**RESOLUTION OF THE BORDENTOWN SEWERAGE AUTHORITY,
IN THE COUNTY OF BURLINGTON, STATE OF NEW JERSEY
AUTHORIZING THE RELEASE OF A PERFORMANCE BOND FOR
BORDENTOWN WATERFRONT COMMUNITY, LLC**

Re: **Bordentown Sewerage Authority
Bordentown Waterfront Community
Phases 1A (Southern Portion) and 1B, East Village
(Rivergate) Apartments, Sanitary Sewer As-Builts
Bordentown Township, Burlington County, New Jersey
Our File No. 0304N056**

**Re: Bordentown Sewerage Authority
Bordentown Waterfront Development
Phase I Route 130 Force Main Extension
Review of Sanitary Sewer Force Main As-Built Drawings;
Testing Summary; and Project Close-out Items
Our File No. 0304N058**

**Re: Bordentown Sewerage Authority
Bordentown Waterfront Development
Phase I On-Site and Route 130 Conveyance System Extension
Second Bond Reduction Request
Our File No. 0304N058**

Attachment 1 – Intercontinental Gas Pipeline Force Main Crossing Casing Detail

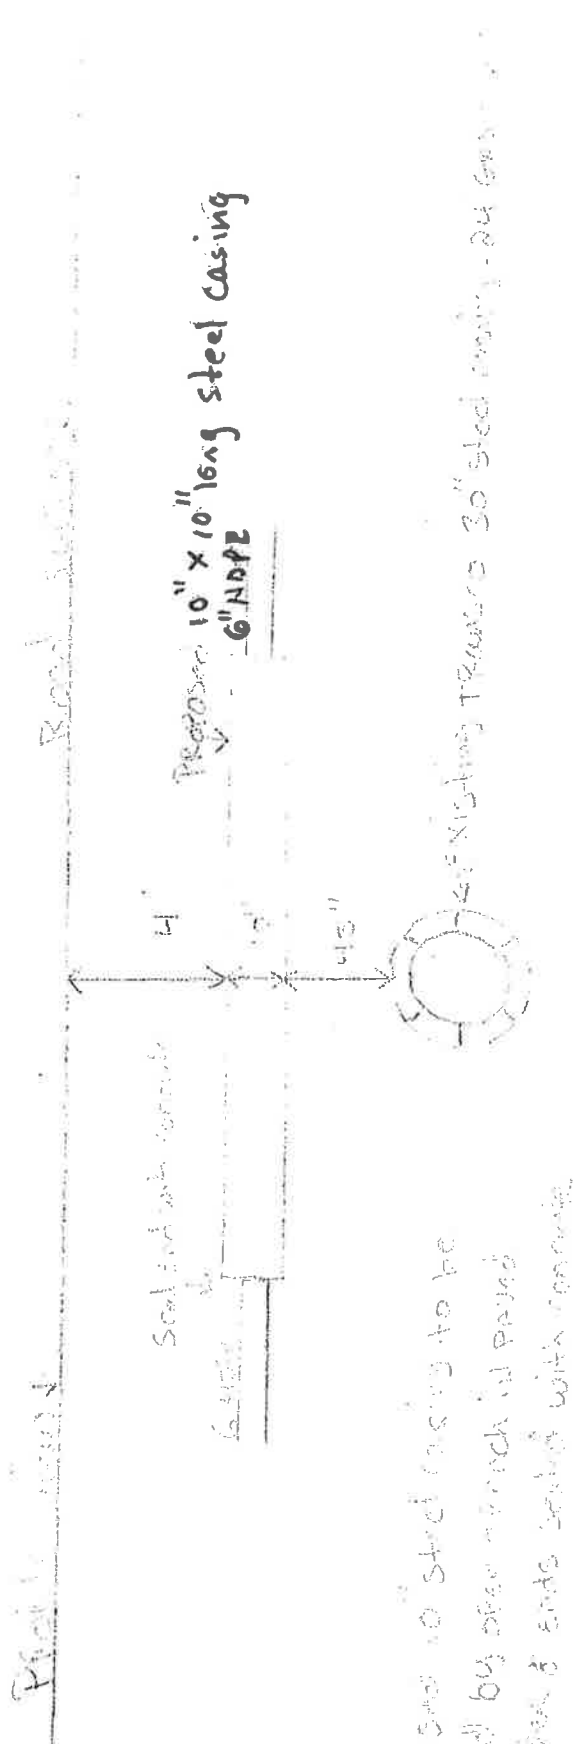
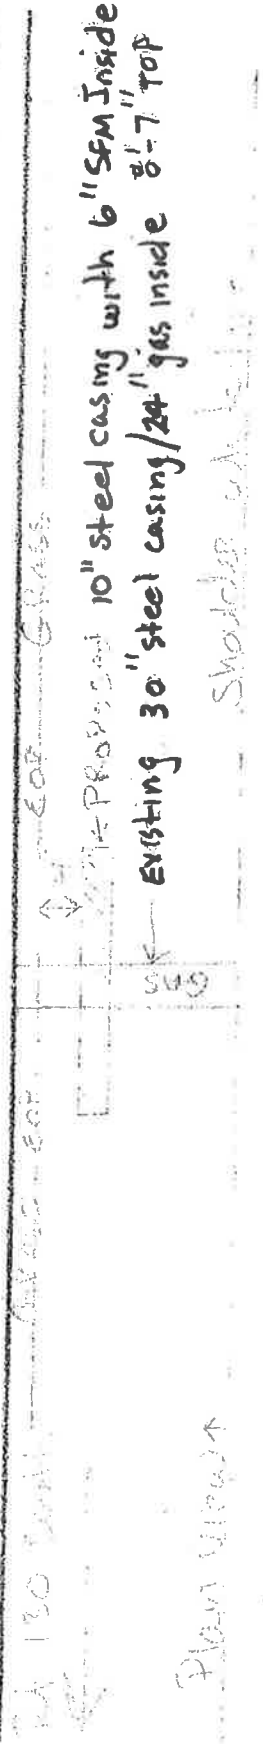
NJSH 130 Station Scale, Station 12+60 shows a sleeve for a crossing of a gas utility pipe. The narrative calls out dimensions but the 45" dimension scales 36". Adjust profile as required. The as-built should indicate what is used as a cap on each end of the casing pipe (concrete) and what was the extra pipe wrapping at each cap to protect the piping service. We were informed the sleeve was centered over the gas main. A copy of the contractor provided detail of the gas line casing is attached herein. A copy within our email which is clearer can be forwarded to the Applicant's representatives upon request.
